**MAHARASHTRA POLLUTION CONTROL BOARD
SUB-REGIONAL OFFICE – PUNE-I**

Visit Report

Sub: Second Interim report for Sewage Treatment Plant Adequacy for VTP Urban Nest, Undri,
Pune

Sub: Third Interim report for Sewage Treatment Plant Adequacy for VTP Urban Nest, Undri,
Pune

Photographs during site visit on 25.11.2022

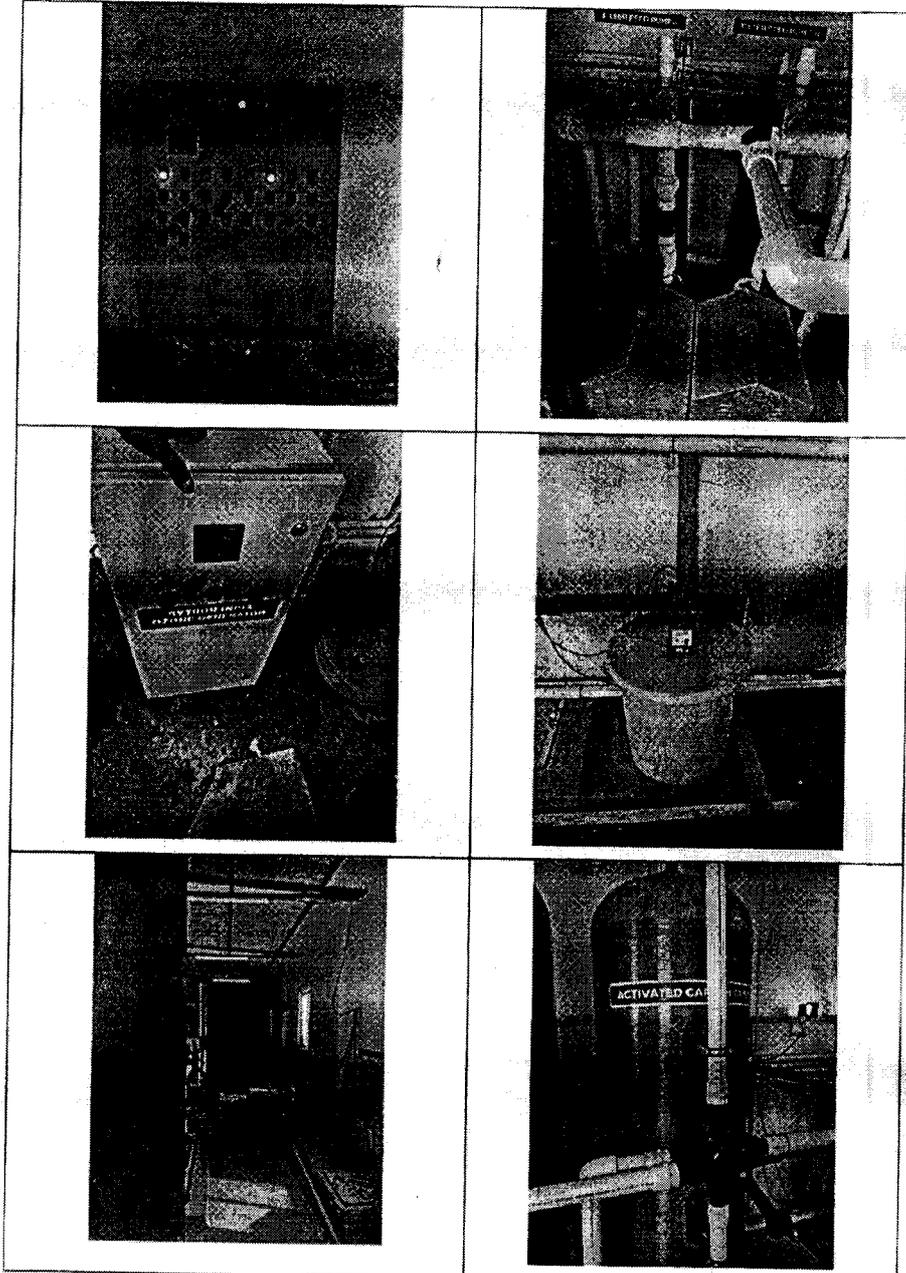
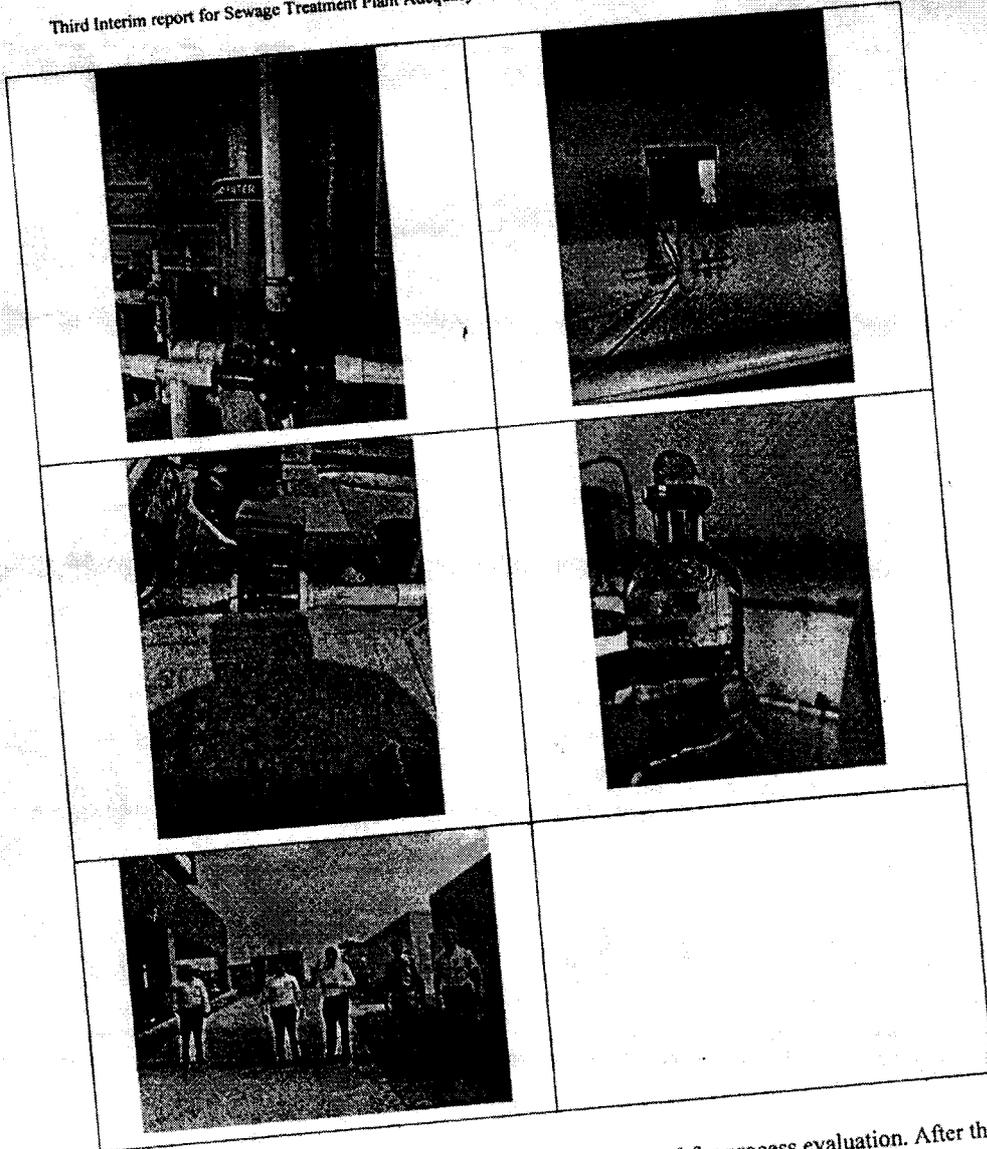
18			It is recommended to provide acoustic treatment for the Air blower rooms to reduce noise levels within prescribed noise levels.	Acoustic Hood is provided. Room is partially covered with foam sheets and pumps were provided with covers.
19			It is recommended to provide deodourising measures to avoid odour nuisance to the surrounding area.	Bio culture is added in equalization tank.
20			It is recommended for appropriate provision for sludge collection and disposal of sludge collected from bar screen and secondary settling tank.	In process.
